**From:** Mark Ostrander <clasictraclayer@att.net>  
**Sent:** Friday, February 21, 2014 4:47 PM  
**To:** Hingtgen, Robert J  
**Cc:** Jacob, Dianne  
**Subject:** Soitec Draft PEIR comments 1 of 2  
**Attachments:** Ostrander Solar PEIR comment edits 02-10-14.docx; Fire Station Dark Days.docx; img011.jpg; img012.jpg

The following are comments and concerns I have in regards to the Solar Projects Draft PEIR Soitec Solar Development Project Log No.: 3910-120005 (ER); 3800 12-010 (GPA); Tierra Del Sol 3300 12-010 (MUP), 3600 12-005 (REZ), 3921 77-046-01 (AP); Rugged Solar 3300 12-007 (MUP).

**IMPACTS OF SOITEC SOLAR PROJECTS  
ON BOULEVARD AND SURROUNDING COMMUNITIES,  
SAN DIEGO COUNTY, CALIFORNIA**

Fig. 11 Preliminary site plan of Tierra del Sol Solar Farm [Click on image to enlarge].

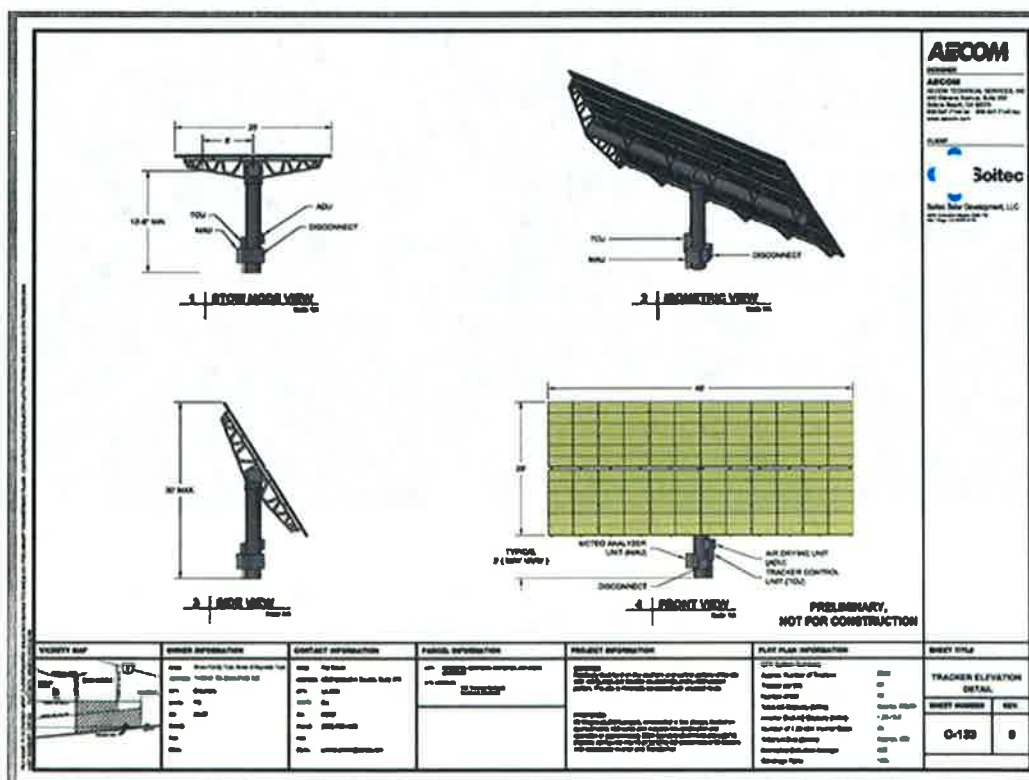
Tierra del Sol Solar Farm features 2,538 units of concentrating photovoltaic (CPV) systems (Fig. 11), utilizing dual-axis trackers with inverter transformer units, with a generating capacity up to 60 MW. Each one of the trackers measures 25' × 48', with a surface area of 1,200 sq ft (Fig. 12).

Fig. 43 Walker Creek meadow relative to LanEast/LanWest Solar [\[Click on image to enlarge\]](#).

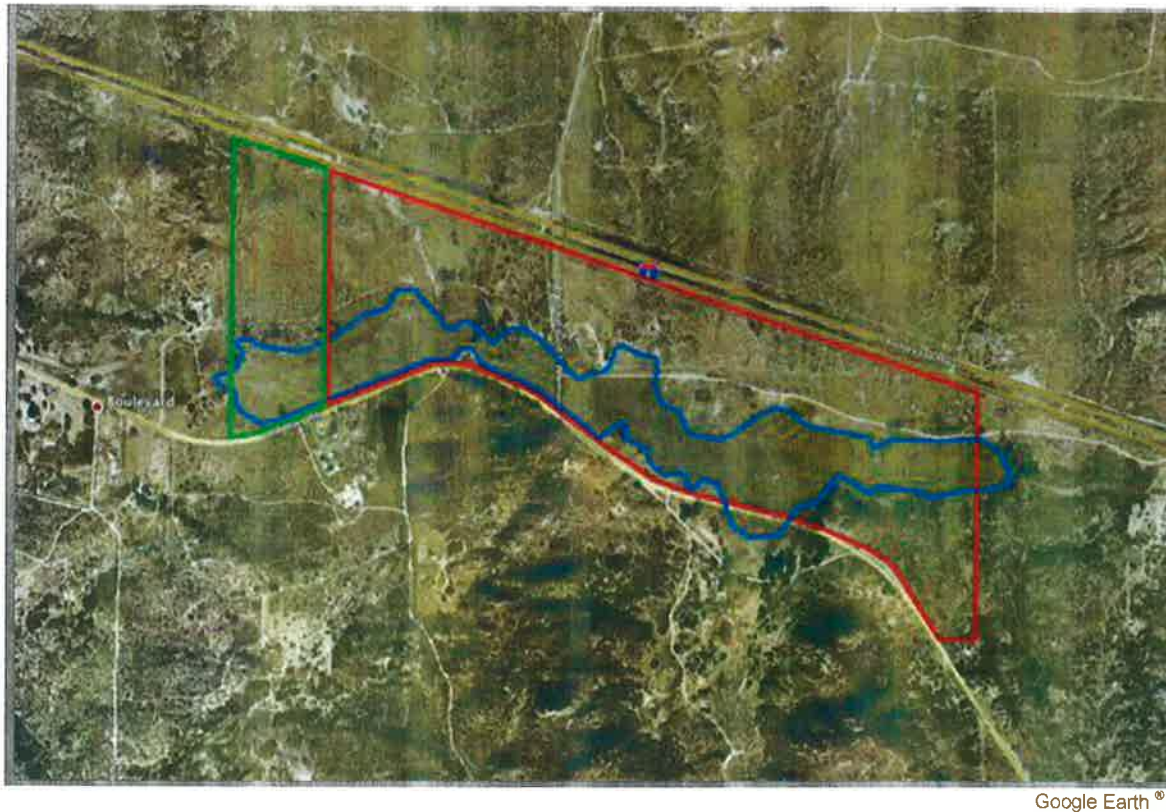
The Walker Creek meadow is delineated in blue in Fig. 43. This figure shows that the LanEast/LanWest project site encompasses almost the entire areal extent of the Walker Creek

meadow. The drainage area of Walker Creek, measured to the furthest downstream point of the meadow, is 10.8 square miles.

The LanEast/LanWest projects are being sited, for the most part, on top of the Walker Creek meadow (Fig. 44). This is an unfortunate tactical decision (Section 6.2). This meadow performs a host of natural services, which will be eliminated or greatly compromised in the event that industrial-scale solar development takes place as planned (Figs. 44 to 46). In the event that the needed amount of project water is obtained from local wells, there is a high risk that the groundwater table may drop below historic levels, with consequent negative effects on the Walker Creek meadow and associated riparian ecosystems.
